HISTORIC DISTRICT COMMISSION MEETING AGENDA

STAFF REPORT
PLHR-2026-00195

SUBJECT: Certificate of Appropriateness request for 403 E. Houston Street

SUBJECT: Certificate of Appropriateness request at 109 N. College Street.

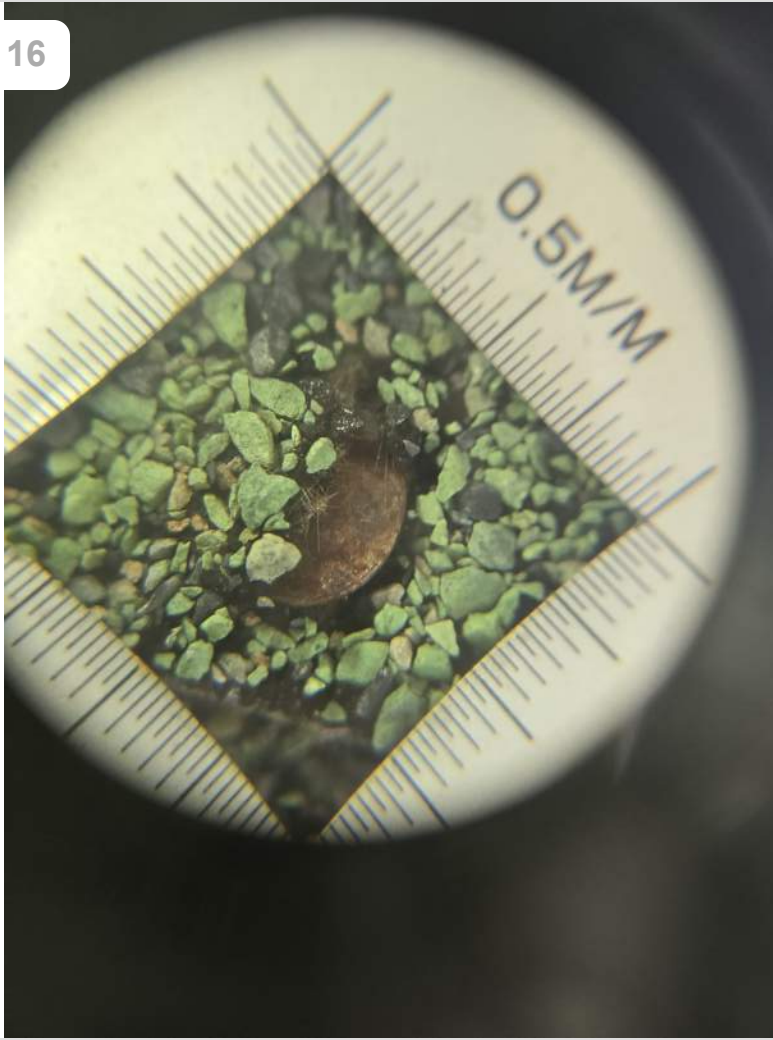
Exposed fasteners were observed on the hip caps. These fasteners should be properly sealed or corrected to prevent potential water intrusion.

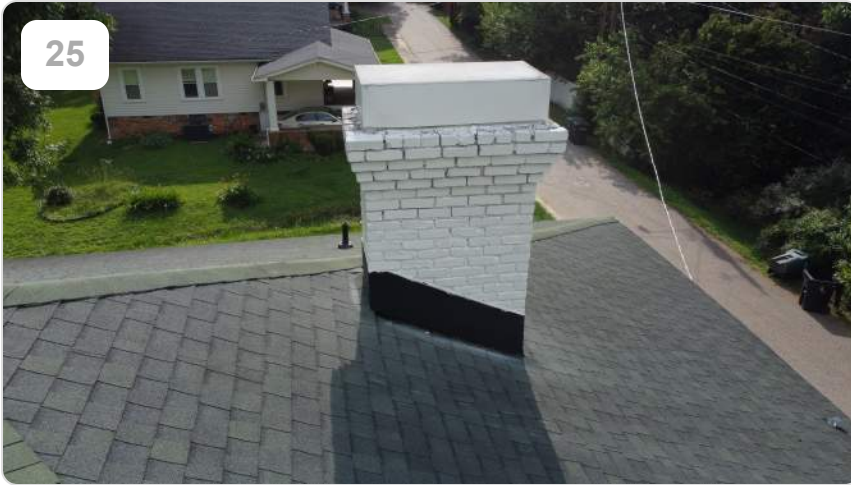
The satellite mounting bracket was found to be loose at the time of inspection. This condition may allow water intrusion around the mounting penetrations and should be properly secured and sealed.
